## CHAPTER 6: CRITICALITY EVALUATION

HI-STAR SAR

Proposed Rev. 10

FIGURE 6.3.4; CALCULATION MODEL (PLANAR CROSS-SECTION)  
 WITH FUEL ILLUSTRATED IN ONE QUADRANT OF  
 THE MPC-24, MPC-24E AND MPC-24E/EF TROJAN.

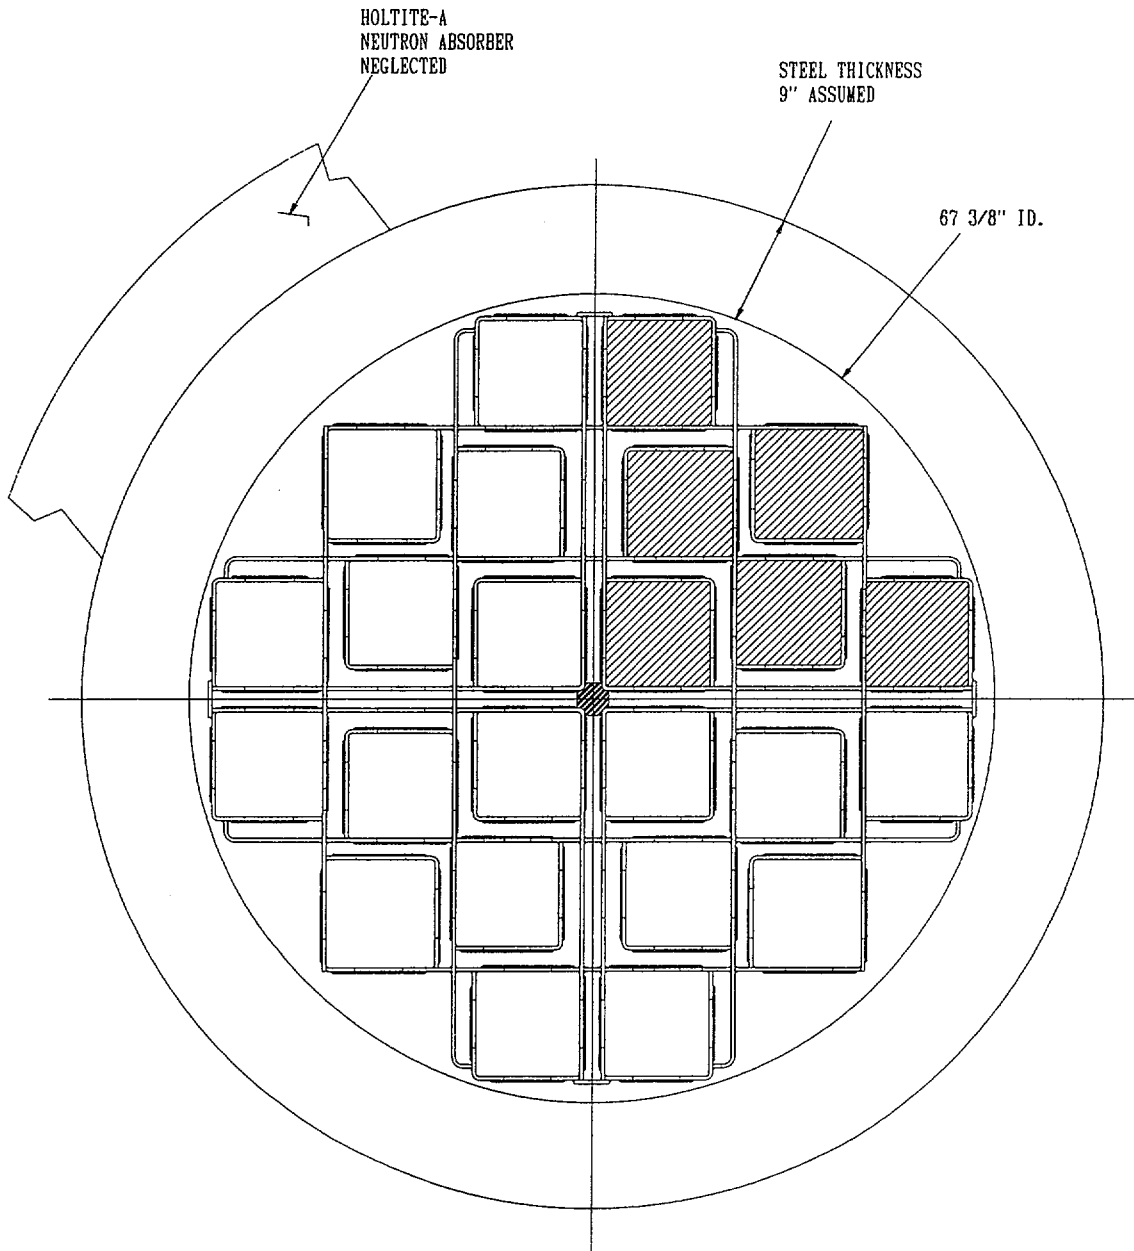
Figures 6.3.1 ~~and~~ *through* 6.3.3 show representative horizontal cross sections of the ~~two~~ *four* types of cells used in the calculations, and Figures 6.3.4 ~~and~~ *through* 6.3.6 illustrate the basket configurations used. ~~Two~~ *Four* different MPC fuel basket designs were evaluated as follows:
